# City of Alexandria, Virginia

## MEMORANDUM

**SUBJECT:** 3<sup>RD</sup> CONCEPT REVIEW OF 2 DUKE STREET  
(FORMERLY ROBINSON TERMINAL SOUTH)  
BAR CASE # 2014-0113

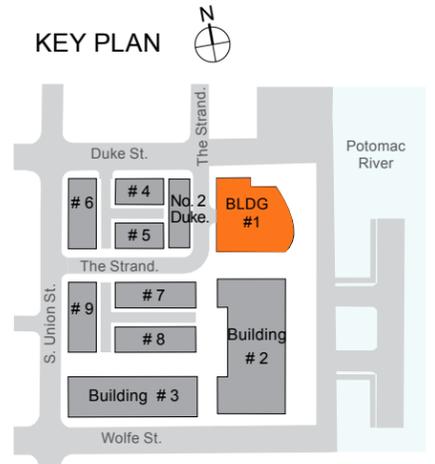
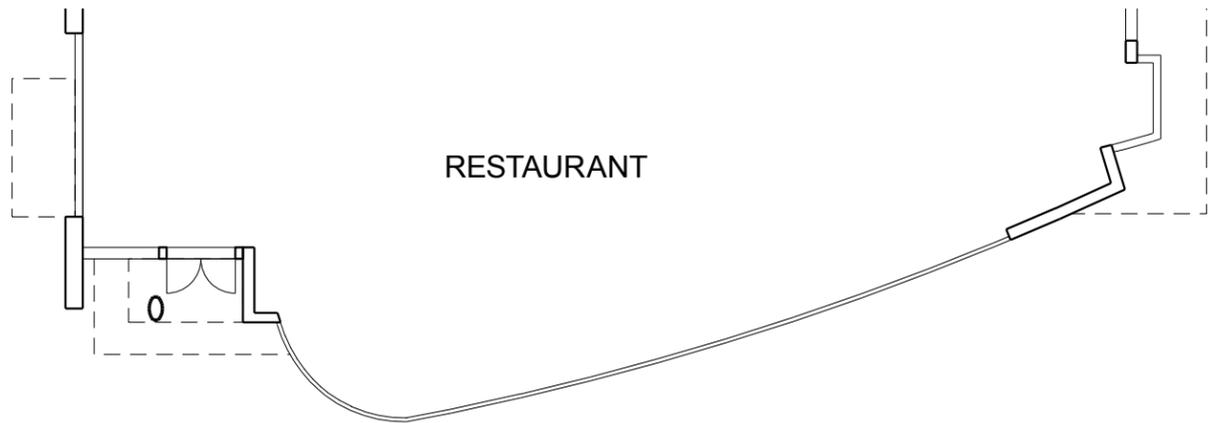
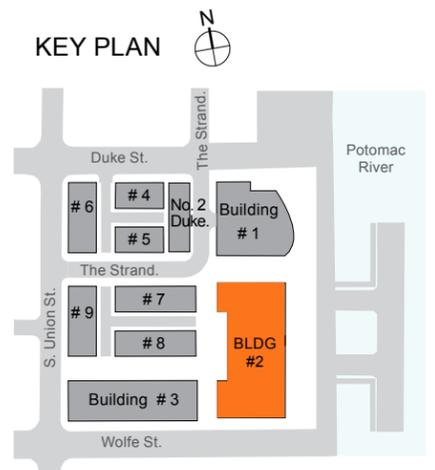
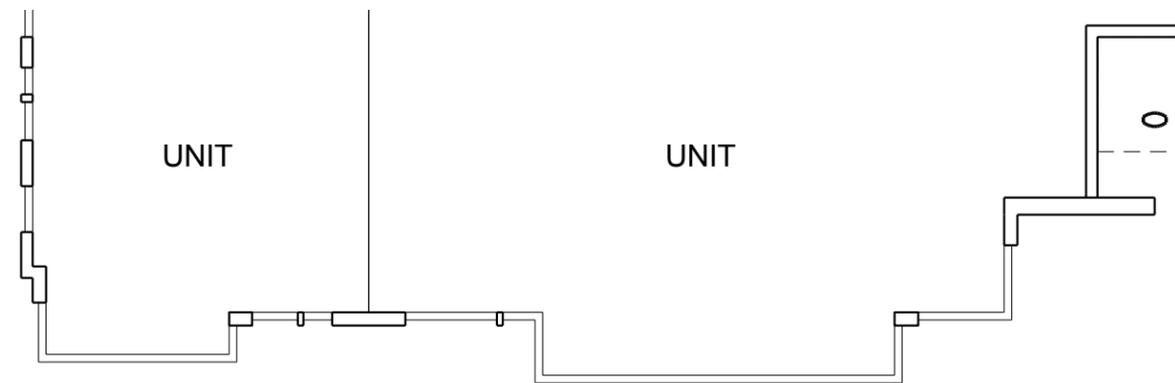
In addition, the architect has rendered this scheme in two alternative colors: one with a gray brick or terracotta tile and one with a reddish hue, although the materials page (Sheet 39) notes that Version B is a yellow/tan brick. Staff's strong preference is to pursue a warm red brick option, similar to the color shown in the rendering and not what is shown on the materials page. The brick or terra cotta wall, depending on the version, provides a strong vertical element that helps to balance the vertical and horizontal elements and breaks the larger building into smaller scale units. This brick wall extends slightly above the roof and reads as a modern interpretation of the firewall that historically separated buildings. Combined with the proposed roof overhang, it will provide integrated rooftop mechanical screening while also contributing to roof-level variety and relief. The masts, which are approximately 15-20 feet above the rooftop will serve a

mechanical function but also provide visual interest, not unlike the smokestacks and flagpoles at factories like the Ford Plant, while referencing the maritime past. The north and south elevations of the waterfront buildings mediate the transparent and reflective waterfront space against the more solid rear elevations and the townhouse areas by increasing the solid wall surface area somewhat and establishing a more formal fenestration.

While the waterfront elevations are quite successful, staff believes that some of the interior elevations of Buildings 1 and 2 continue to need refinement, as staff and the Board asked the applicant to focus first on the more important waterfront elevations of these buildings. For example, the street-level of the west elevation of Building 1 appears to be designed around the loading and parking doors, resulting in a two-story stone “foundation” and awkwardly proportioned pedestrian doors. This will be a primary entrance to the site for both cars and pedestrians and must mediate the two scales (vehicular and pedestrian) and successfully maintain an appropriate relationship with the street.

- Pursue the red brick option for the two waterfront buildings and provide brick samples.
- Render the glass accurately and indicate whether it will have a tint or reflective quality. It may be appropriate to use fritted or frosted glass as accents.
- Consider how solar control will be achieved where there is significant glass and how solar shades may be integrated into the overall design.
- Refine the proportions of the doors, loading area and foundation materials on the west elevation of Building 1 and refine other interior elevations.
- Provide samples of the proposed materials palette.

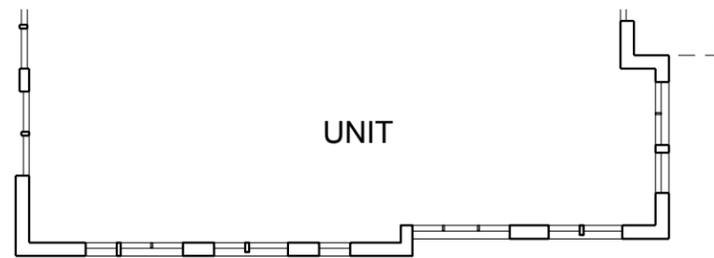
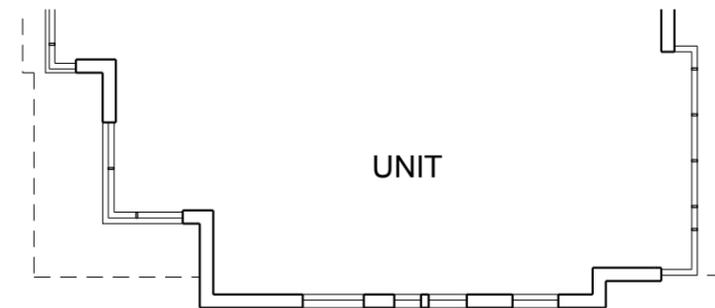
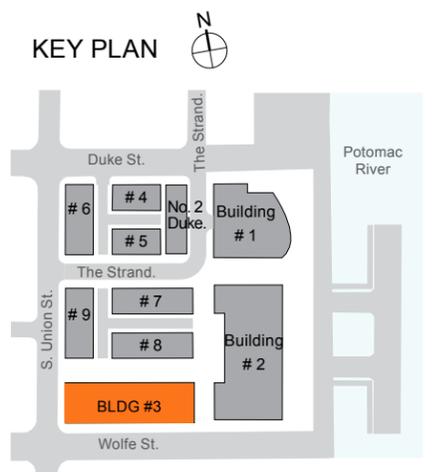
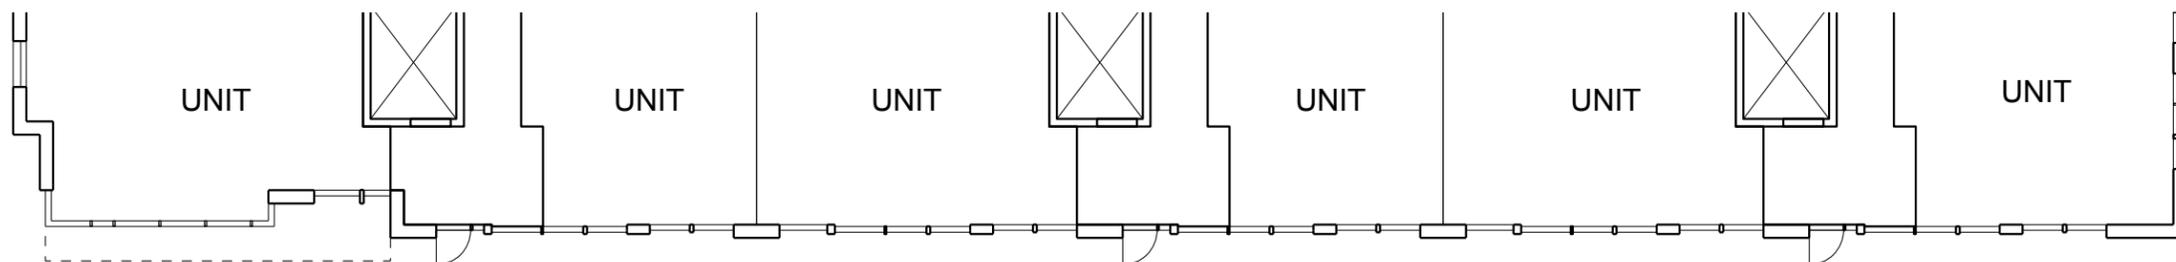
The design intent to mediate the more traditional forms and materials of the townhouses against the more contemporary waterfront multifamily buildings at the third multifamily building at the corner of Wolfe and South Union streets is appreciated and can provide architectural variety. However, staff finds that this third multifamily building is less successful than the two multifamily buildings on the waterfront. The four elevations seem disjointed and should relate better as this building will be experienced on all four sides. While the Wolfe Street elevation (south) has a clearly established rhythm and balanced fenestration, the entrances should be enhanced and relate to the adjacent streetscape which will lead to a future park. The rear (north) elevation needs significant refinement.

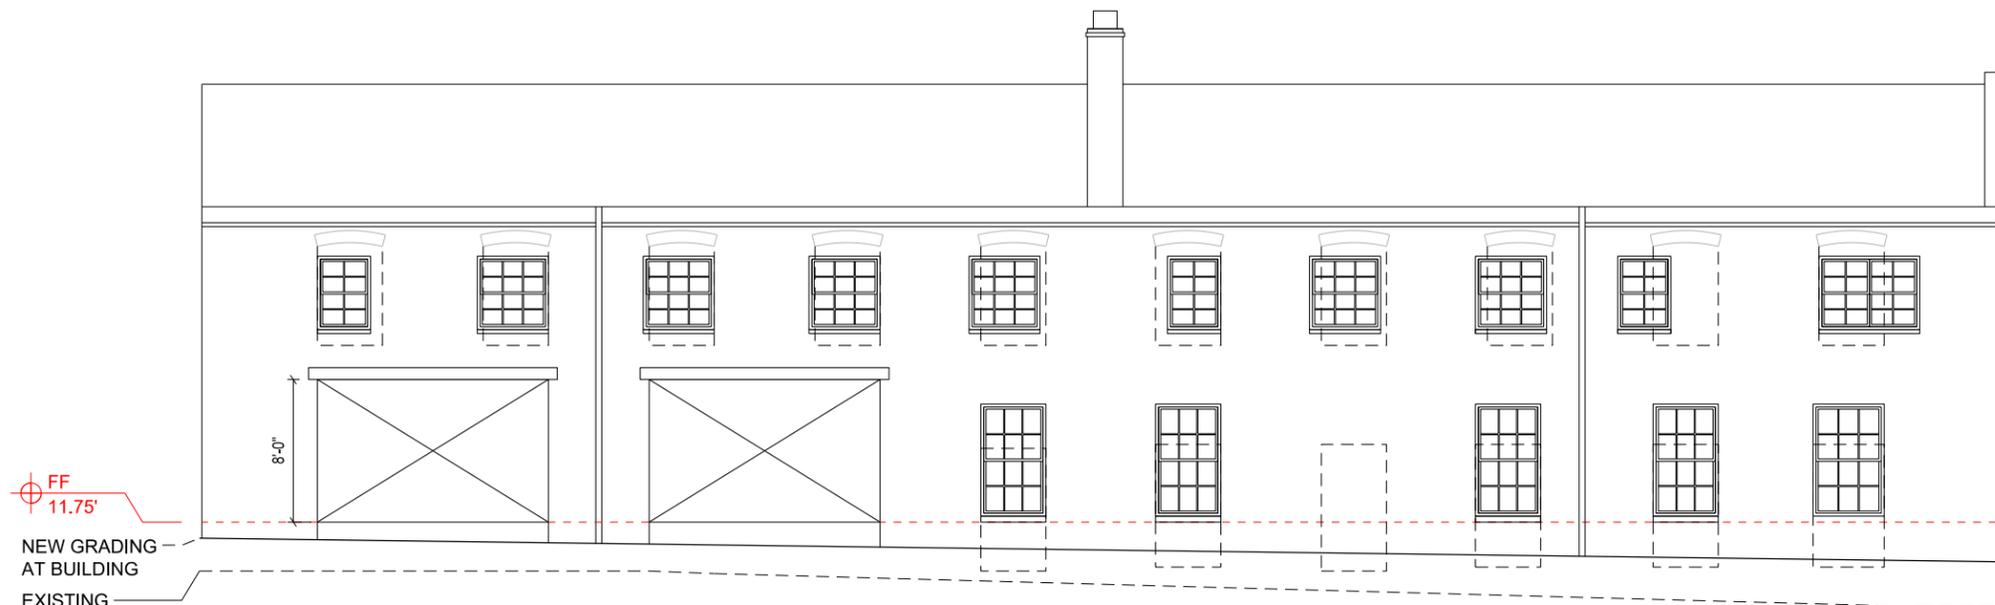
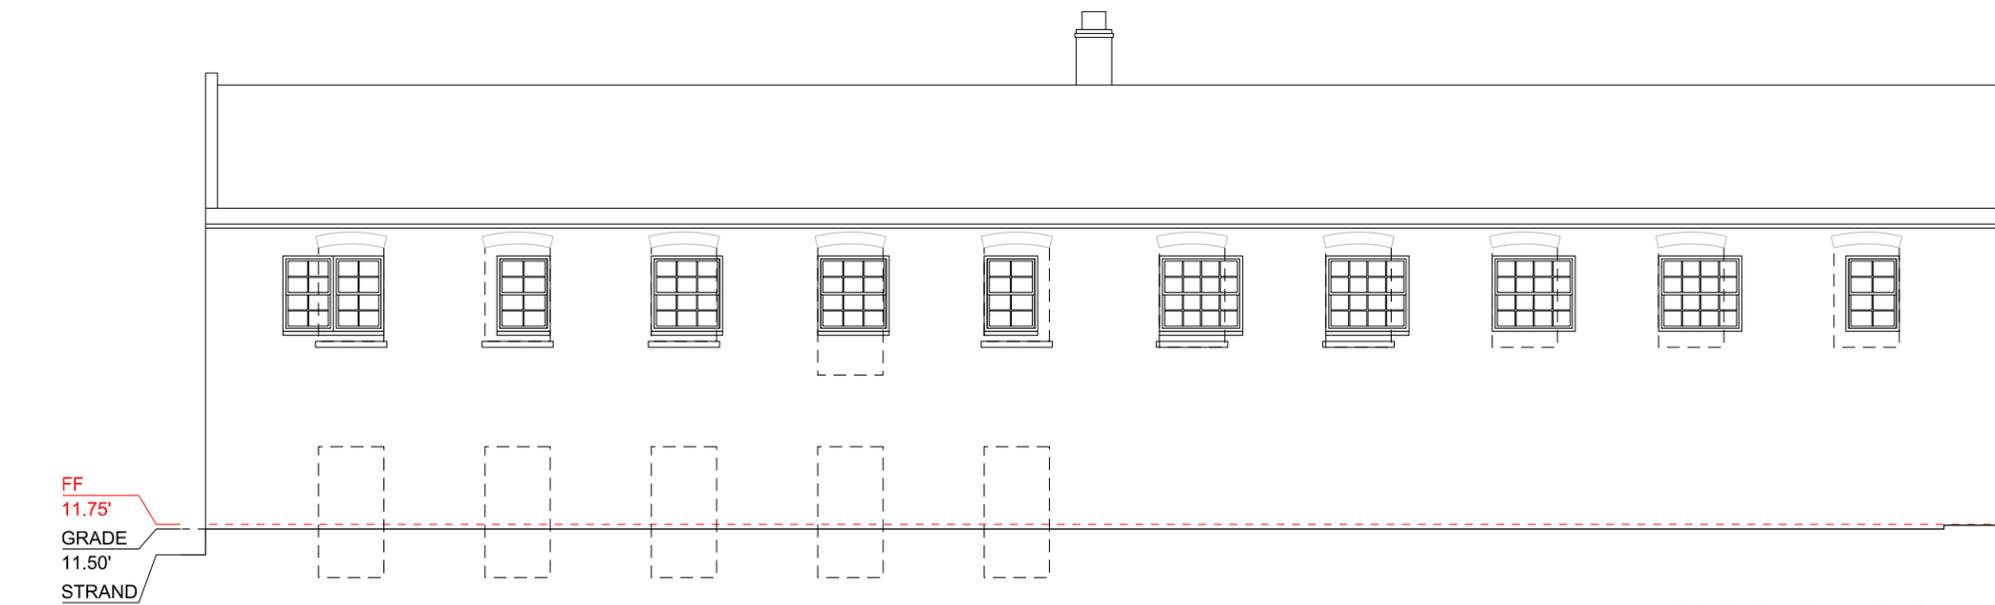
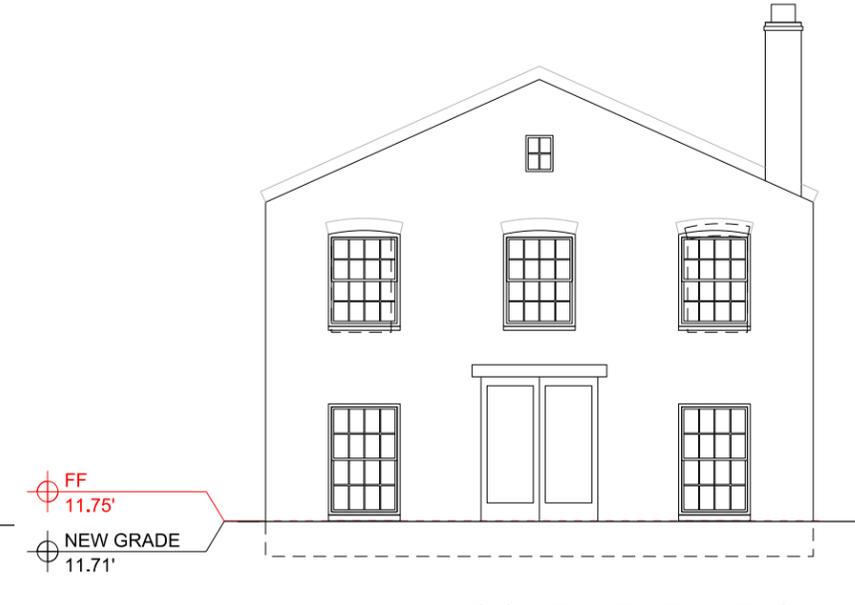
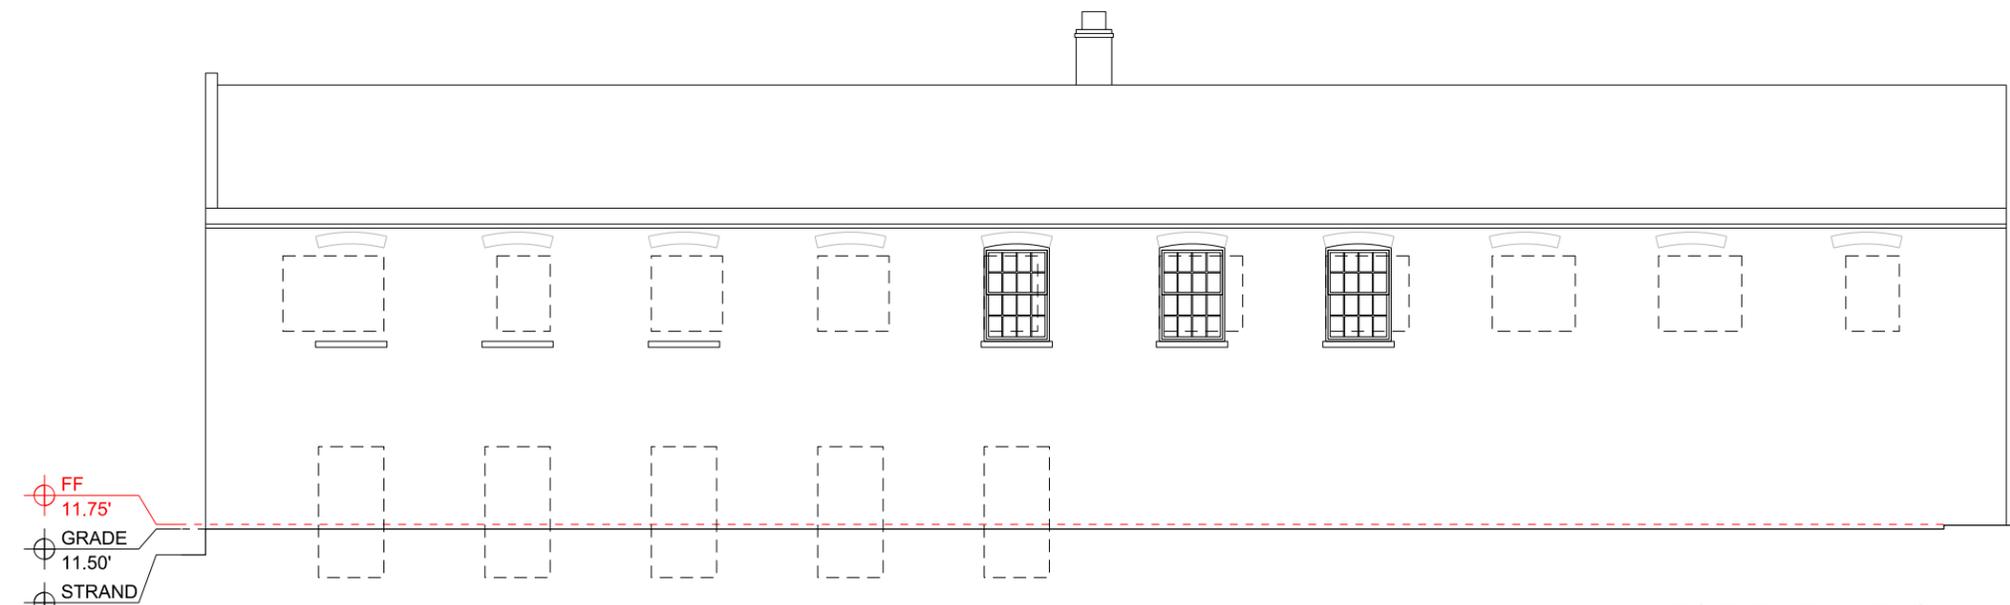
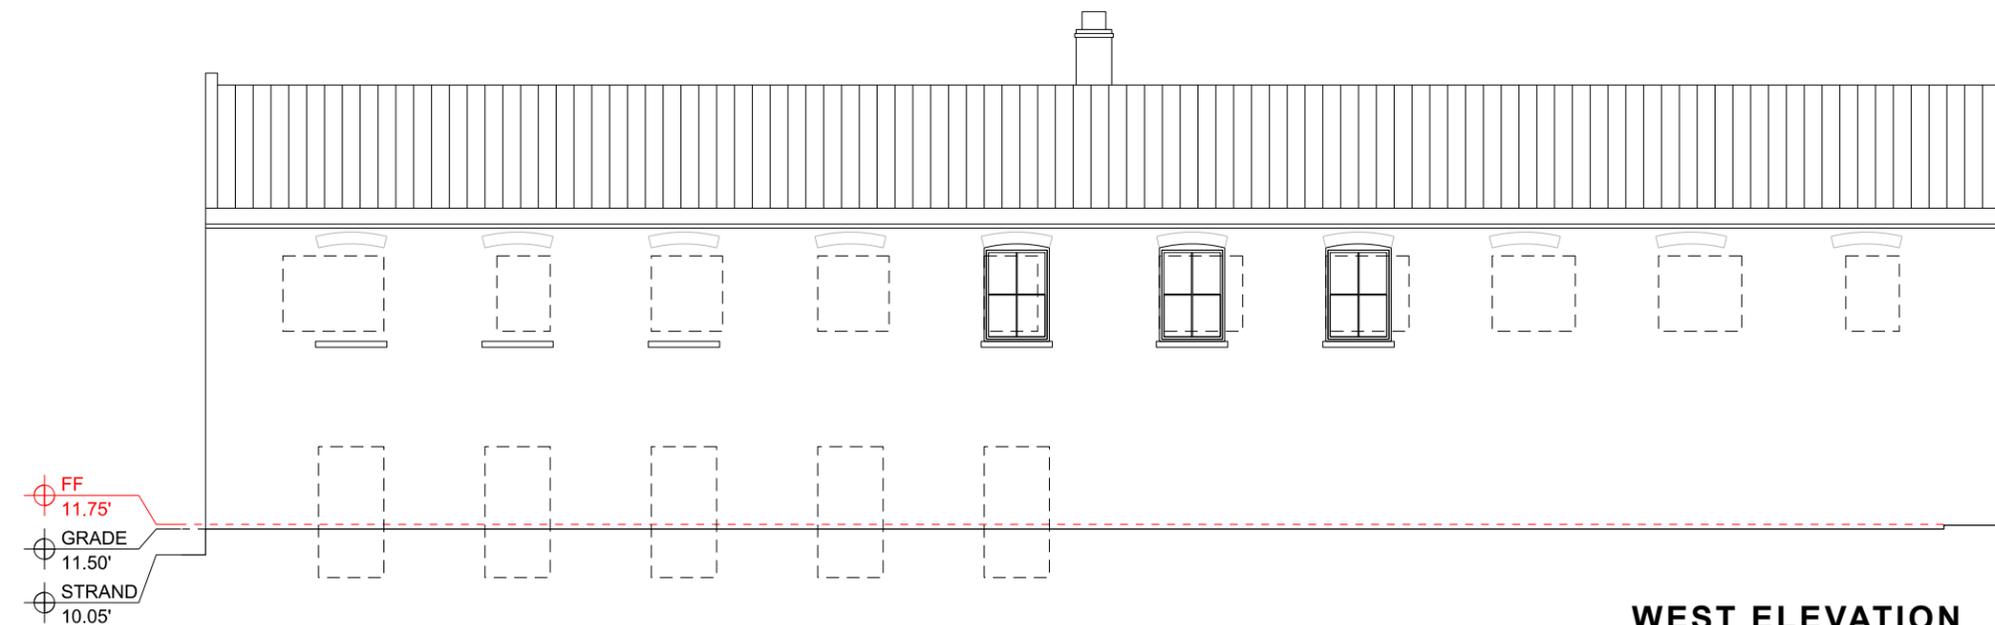
Ms. Finnigan was very pleased with the proposed treatment and thought it had great potential for a market. She supported the changes but requested that the entrance steps on Duke Street be opened up more to be more inviting.

Mr. Carlin agreed with Ms. Finnigan. He found that the building's most important components: the cornice, gable form roof with heavy timber trusses and the punched brick openings would be retained. He agreed with Ms. Finnigan and suggested a broader entry stair.

As he stated at the previous work session, Mr. von Senden strongly recommended that the alley on the west side of 2 Duke be extended to at least ten feet in width, typical of the minimum alley width found in Old Town. He noted that the townhouse strings could be slid westward to accommodate this without losing floor area. He thought the wide openings on the east elevation would read as doors and encouraged them to be active, depending on the tenant. He preferred the aligned windows with metal spandrels in lieu of the brick spandrel form. He reiterated the need to make the Duke St. entrance more inviting.

Ms. Miller agreed with Ms. Finnigan and Mr. Carlin. She thought it was appropriate to open up the interior and possibly convert it to a market. She also wanted to see a more inviting and embellished entrance and supported a 10' wide separation on the west. She advised the architect to pay attention to detail with this building as well as throughout project.

Ms. Roberts agreed with all of the comments made by the other BAR members but preferred the brick spandrel option, as opposed to the metal spandrels. She also wanted the "alley" to the west to be widened as much as possible, citing concern that the townhouses could loom over the smaller historic structure.

Chairman Fitzgerald preferred the window scheme without any spandrel and that just reflected the original punched window openings, though he understood the applicant's desire for a vertical proportion on the shortened building. He advised against making too many changes to the front entrance but agreed that the stairs should be improved to make it more inviting without losing the warehouse character. Overall, he was pleased with the work on this building.

The applicant has shown three options for the rehabilitation of the building as it relates to the fenestration. It should be noted that all of the options will change the proportions and scale of the building as it will effectively be lowered by burying the bottom of the building 5.5 feet (on the front elevation, less on side elevations and indeterminate on south elevation) due to the grade changes. The first option replaces the windows in the current, non-historic locations. The second option restores the original window locations at the first and second stories. The third option returns the original window locations at the first and second stories but employs a two-story bay window in the original locations. The applicant also proposes to fill in some openings on the west elevation and to create a likely front (north) elevation based on similar warehouse buildings shown in historic photographs. As this building has been modified extensively, yet still retains a high level of historic integrity, the proposal here is more of an adaptive reuse rather than a strict rehabilitation. Based on the modifications over time and the contextual proposal, staff supports this approach. Previously, the Board noted that an accessible pedestrian alley between the west elevation and the new townhouses should provide as much space as possible, with 12 feet as one previous suggestion. The current proposal for alley width is 7.8 feet which is

- Continue to explore the two-bay scheme for adaptive reuse.
- Provide additional information about the treatment of alley on west side of 2 Duke Street and explore widening the alley.
